Department of Transportation

MEMORANDUM

DATE: September 23, 2019

SUBJECT: ZC Case No. 15-20C – Sursum Corda First Stage PUD Modification and Phase 1 Second Stage PUD

Figure 2 Circulation Plan with L Street's Wider ROW

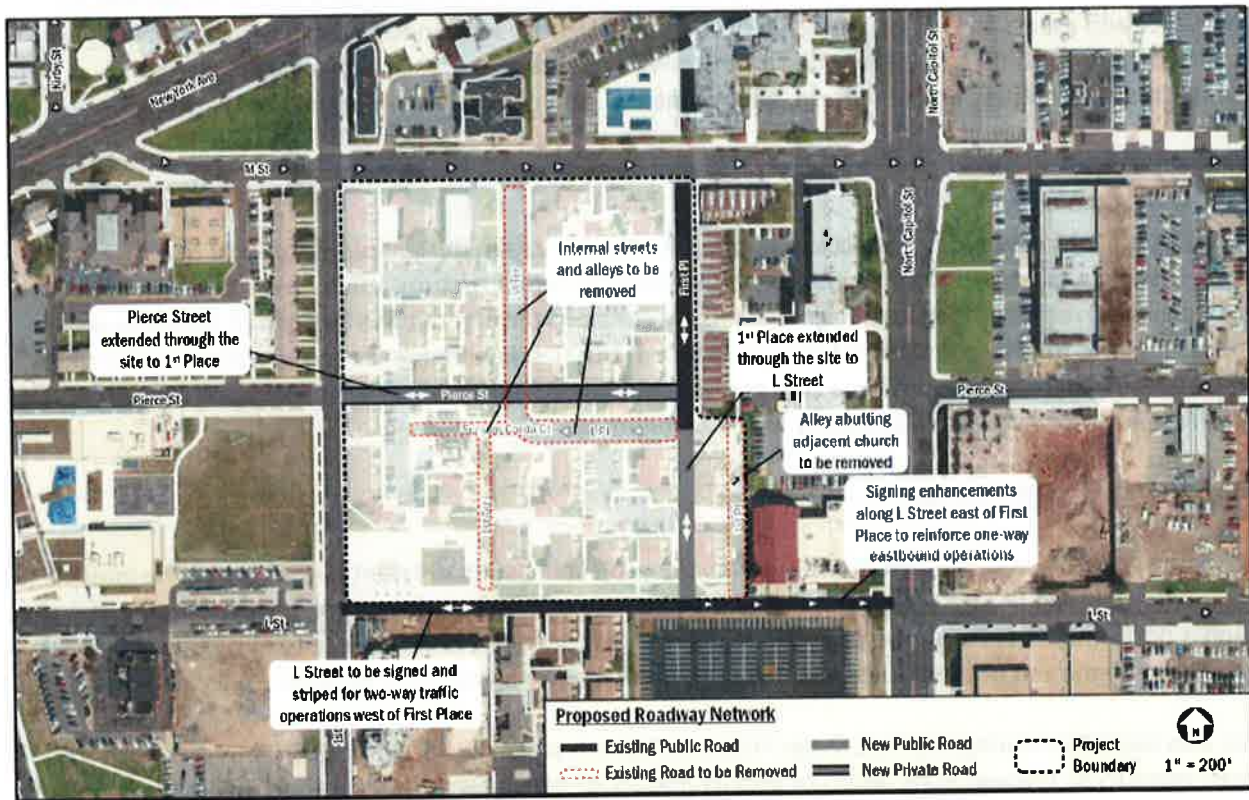
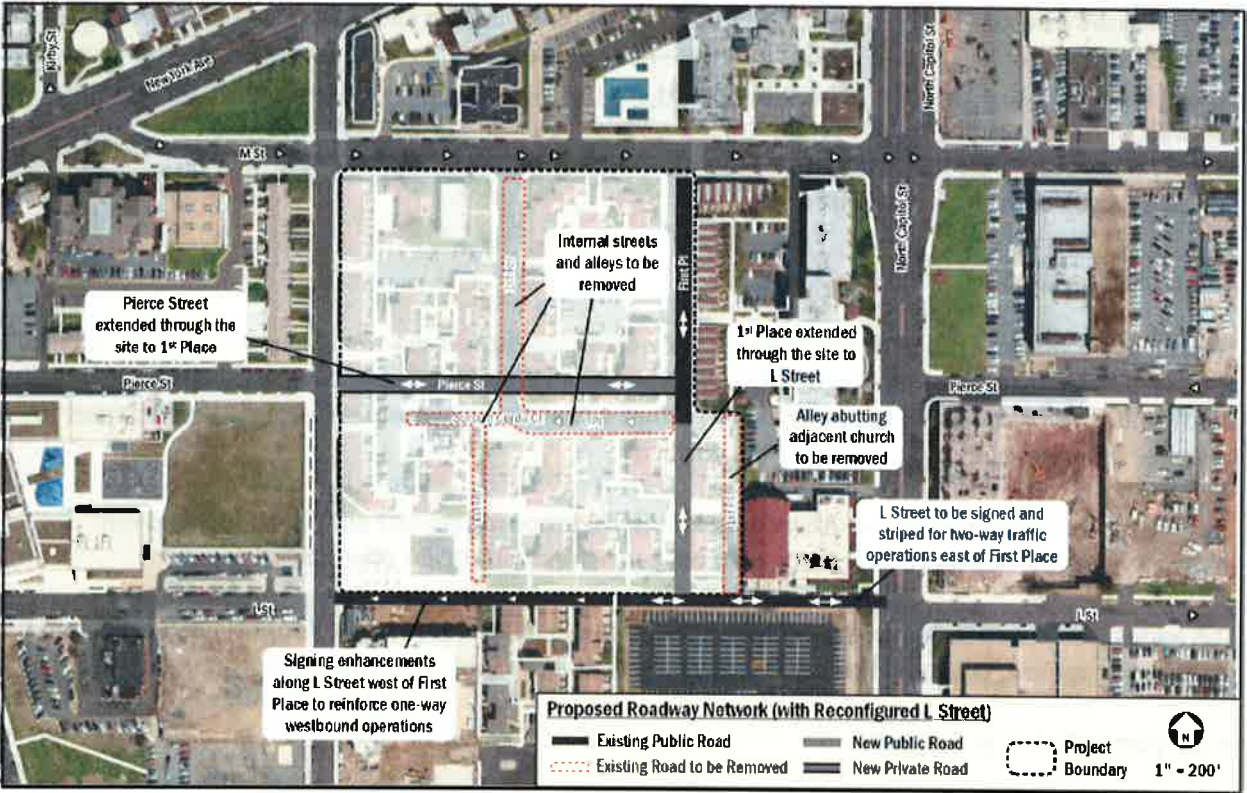
DDOT strongly supports this approach to widen L Street between First Place and North Capitol Street because it allows for the northern curbline to be set in its ultimate location, thus eliminating the need to relocate the northern curbline in the future when L Street can be widened to its historic ROW width for the entire block. This option also has the added benefit of providing a DDOT-standard sidewalk along the entirety of the north side of L Street between North Capitol Street and First Street, including in front of Mount Airy Baptist Church where today the stairs terminate abruptly in the street and no sidewalk is provided.

Figure 4 Southwest Building Loading Distances (Source: Exhibit 42)

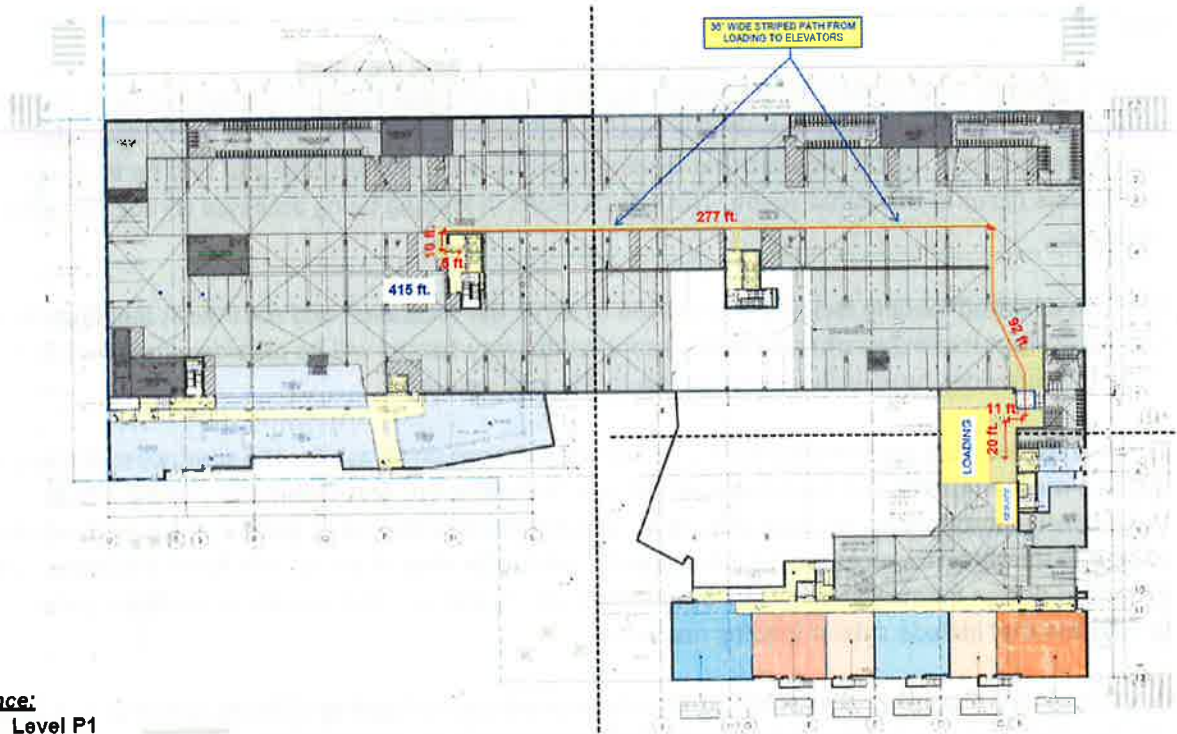
This loading location requires residential move-in/move-out and trash for the southwest building to utilize a mechanical lift and travel upwards of 675, including 415 feet within the parking garage rather than a designated loading corridor (Figure 4). The Applicant proposes to paint a walkway through the garage to demarcate spaces where loading and trash traffic should travel. The Applicant believes the proposed design meets the building's operational needs and included several examples of other properties that include similar loading distances.

DDOT finds the loading design does not meet best practices for loading facilities, which would include shorter distances to a building's loading facilities that would be connected via a designated loading corridor, and believes that there will be pressure for loading and trash to occur via the Pierce Street curbside. This is important because access to Phase 2's loading facilities accessed via Pierce Street may conflict the proposed curbside on the south side of Pierce Street. If curbside loading for the southwest building takes place from the south curbside of Pierce Street, it will likely block vehicular traffic on the street and conflict with the proposed streetscape design proposed for Pierce Street.

The Applicant will be required to refine their loading access for Phase 2 during the Second Stage PUD such it is consistent with the Pierce Street cross section established as part of the Phase 1 Second Stage PUD.
